## **MOSTELLAR PARK SUBDIVISION**

APPLICATION NUMBER 2 DATE February 3, 2021

REQUEST Subdivision

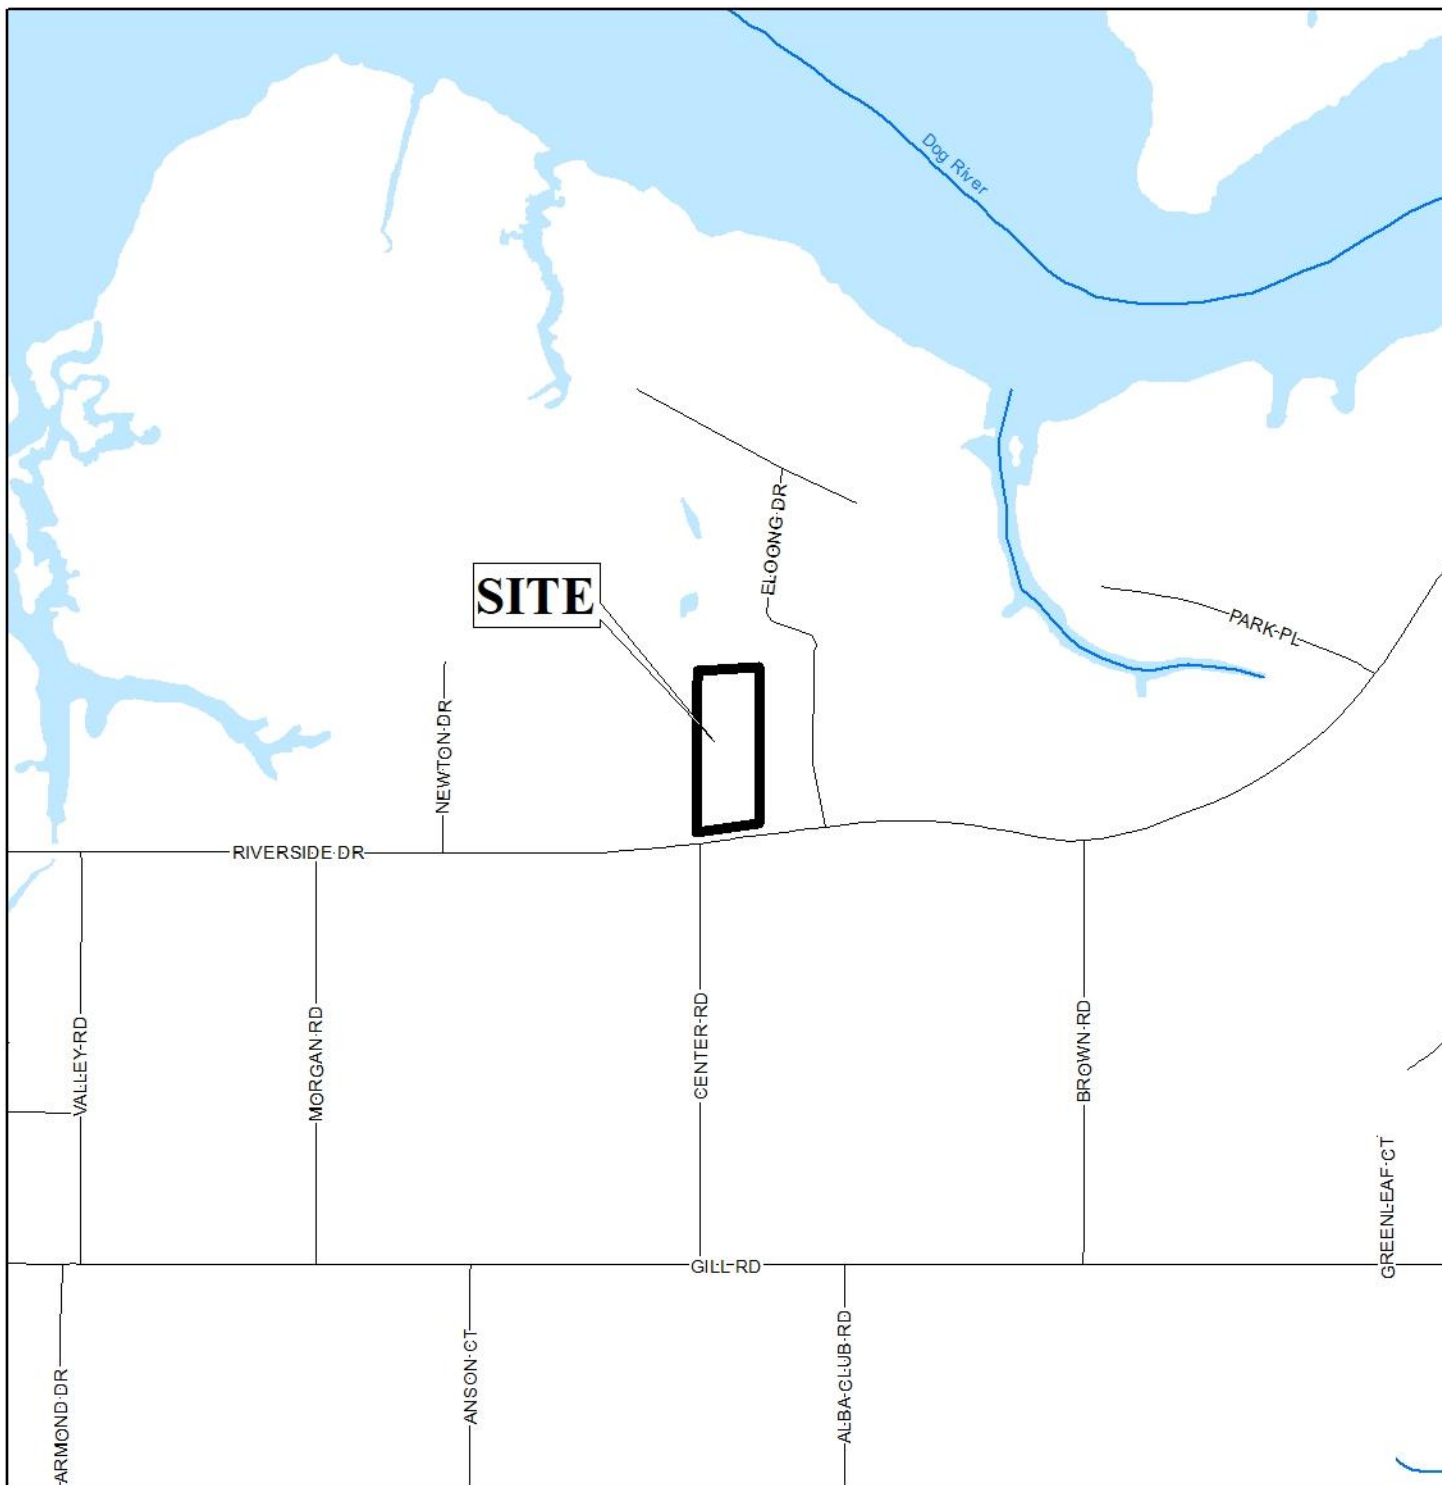
The proposed lots have frontage along Riverside Drive, a minor street without curb and gutter requiring a 60' right-of-way. No right-of-way is depicted on the plat; as such, either depiction of sufficient, current right-of-way or dedication to provide at least 30' from the centerline of Riverside Drive should be required, if approved.

The 25' minimum building setback line required by section V.D.9. of the Subdivision Regulations is illustrated where each lot is at least 60' wide, and should be retained on the Final Plat, if approved, adjusted for any required dedication.

Proposed Lot 2 is irregularly shaped and may be regarded as a "panhandle" lot, which is a lot design generally discouraged by Section V.D.1. of the Subdivision Regulations; the exception being the approval of lots located where varied and irregularly shaped lot designs are common, and the informality of design is consistent with other lots in the vicinity. The Planning Commission has approved a similar design for several lots within the vicinity of the subject site, therefore a waiver of Section V.D.1. may be appropriate.

The lots meet the minimum size requirements for lots served by public water and sanitary sewer systems and are appropriately labeled with their sizes in square feet and acres on the preliminary plat. This information should be retained on the Final Plat, if approved, or provision of a table on the Final Plat providing the same information may suffice.

Finally, in recent aerial photos the site appears to be developed with a single-family dwelling and accessory structure. A demolition permit for the structures was issued in April, 2020, thus completion of the demolition should be required prior to signing the Final Plat, if approved, to address probable zoning violations.

- 1) either revision of the plat to depict a compliant right-of-way along Riverside Drive, or dedication to provide 30' from the centerline of Riverside Drive;
- 2) retention of the 25' minimum building setback line where each lot is at least 60' wide, adjusted for any required dedication;
- 3) retention of the lot sizes in both square feet and acres on the Final Plat, or provision of a table on the Final Plat with the same information;
- 4) demolition of the structures on the site prior to the signing of the Final Plat;
